Dare County ABC Store - Buxton

Addendum No. 5

June 23, 2023

Project Name:
 ABC Buxton

① Light Pole Foundation
 3/8" = 1'-0"

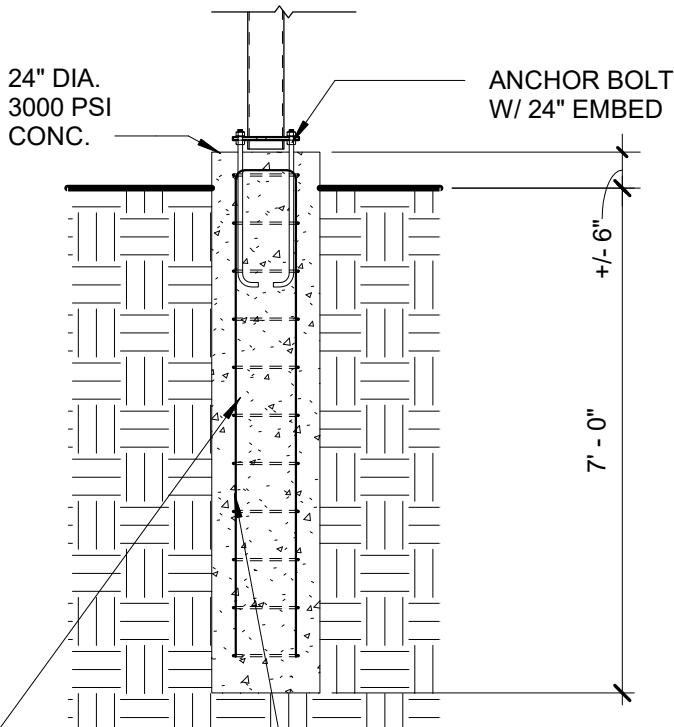
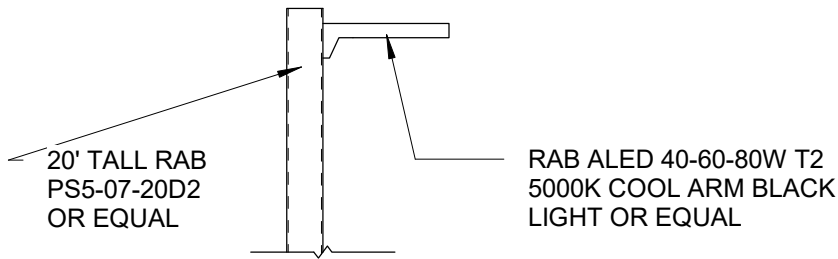
1. See attached parking lot light pole foundation detail. This drawing details construction for the two parking lot lights as indicated in Note 5 of Addendum 4. The detail changes the foundation from 12" diameter concrete 5' in ground to 24" diameter concrete 7' in ground. The light pole has been specified as a 20 pole RAB PS5-07-20D2 or equip.
